Re: Kittery Aroma Joes | Planning Board Review Comments

Proposed Coffee Shop
523 Route 1
Kittery, Maine

PROPOSED SITE PLAN

**RE: Town of Kittery, Planning Board Services
523 US Route 1, Aroma Joe's Site Plan Review Application
Tax Map 66, Lot 26; Mixed Use (MU) Zone
CMA #591.139**

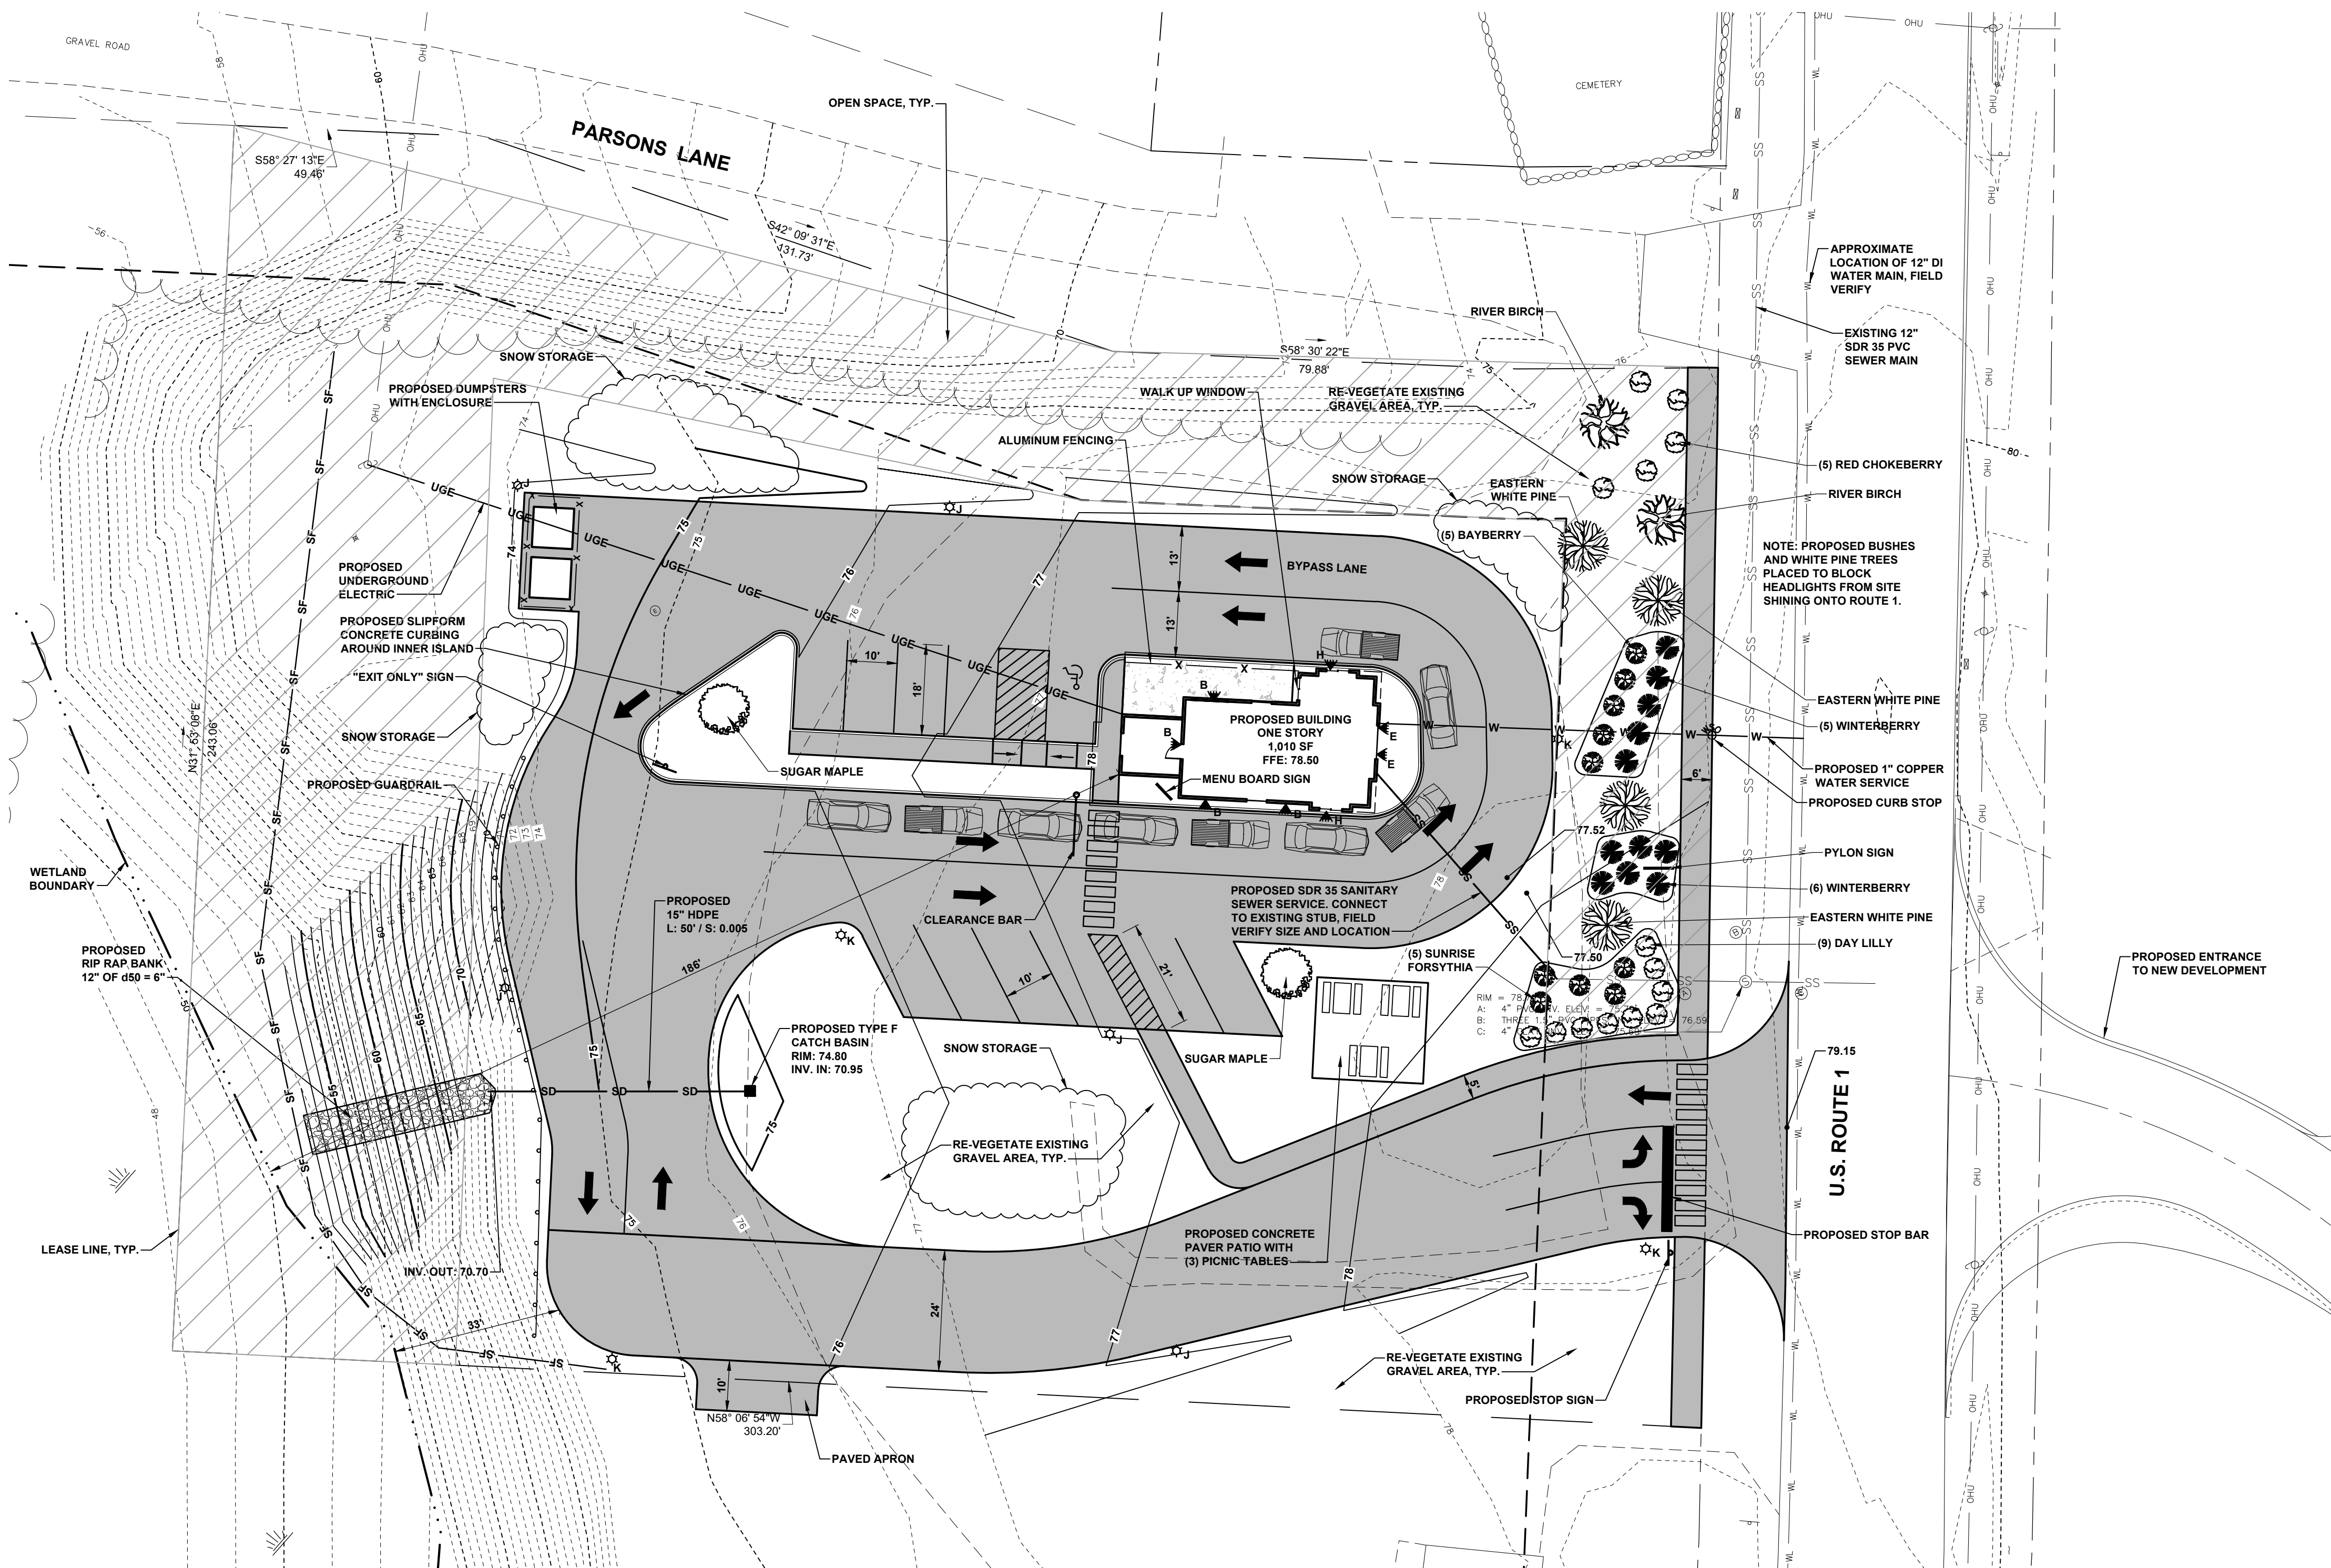
- 2. The applicant should add the pre and post development impervious area numbers to the plan.**

4. Please add snow storage areas to the site plan and note that snow will be removed from the site if the storage areas become full.

5. Provide information on the proposed plantings and how they will screen headlights from shining onto Route 1.

The attached revised site plan includes these numbers in the project summary table.

Please refer to the attached revised site plan.

The proposed plantings were selected based on the town ordinance. We revised some of the tree's species to provide more evergreen plantings instead of deciduous. The trees are all 12' tall at time of planting, and the shrubs are all 2-3 feet high at time of planting. We believe that we have strategically placed them in order to keep headlights from shining into the road.

PROJECT	GCS ENTERPRISES LLC US ROUTE 1, KITTERY, MAINE		DWG No.	1	BY	WAB	DRAWING STATUS
	ALTERNATE ENTRANCE SKETCH		JN	13522.001	DATE	2022.02.28	
TITLE					SCALE	1"=30'	REV.
				REV. DATE		NOT FOR CONSTRUCTION

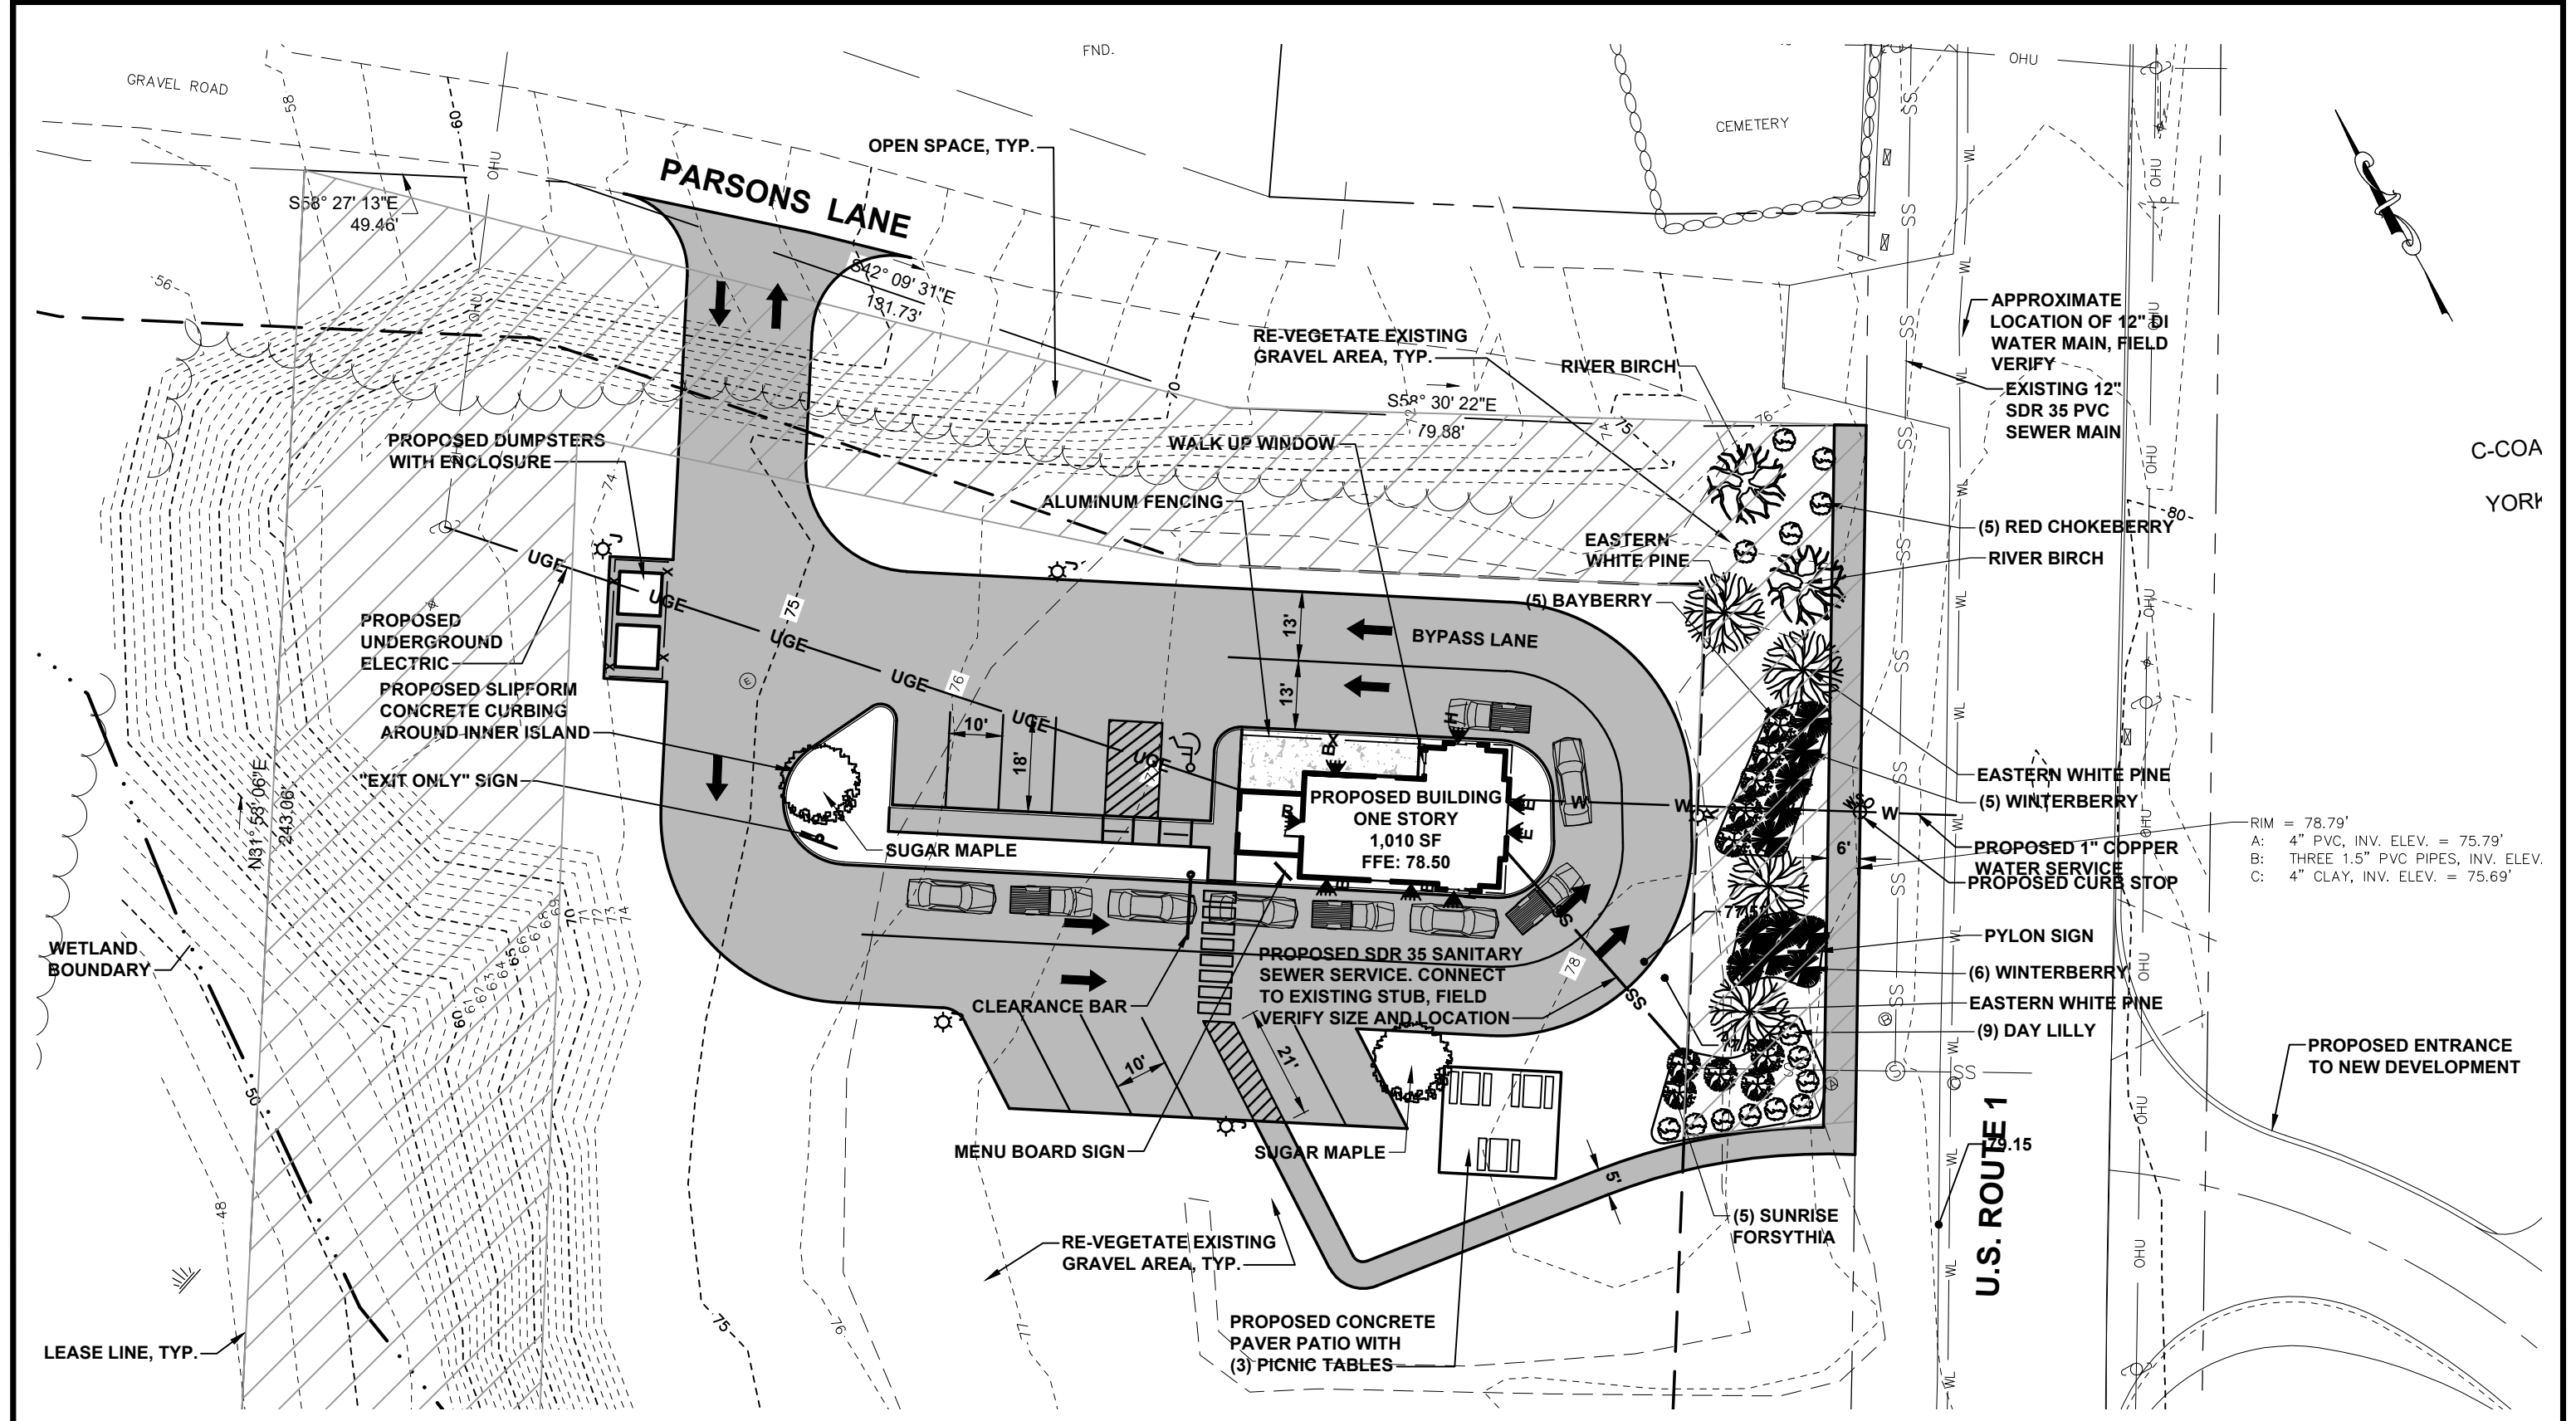
- 1. The applicant should request a waiver to have the site access located on Route 1 instead of Parsons Lane. Include a sketch of what the Parsons Lane access could look like. Include reasons why access from Parsons Lane is not feasible.**

We request a waiver as noted above for the site access to be located on Route 1 as shown on our proposed site plan. Attached to this letter is a sketch showing what the access could look like from Parsons Lane. Parsons Lane is a private drive that is not suitable for commercial use. There are safety issues with the proximity of the existing drive to the existing business to the north. Adding a commercial traffic entrance adjacent to that existing business would create serious safety issues for vehicles from both locations entering and exiting. The site access has been discussed in detail with MaineDOT through our Traffic Movement Permit process, and it has been determined that the access as proposed, directly across Route 1 from another new commercial entrance, is the best location. We would also note that this location is very close to the existing entrance to this lot.
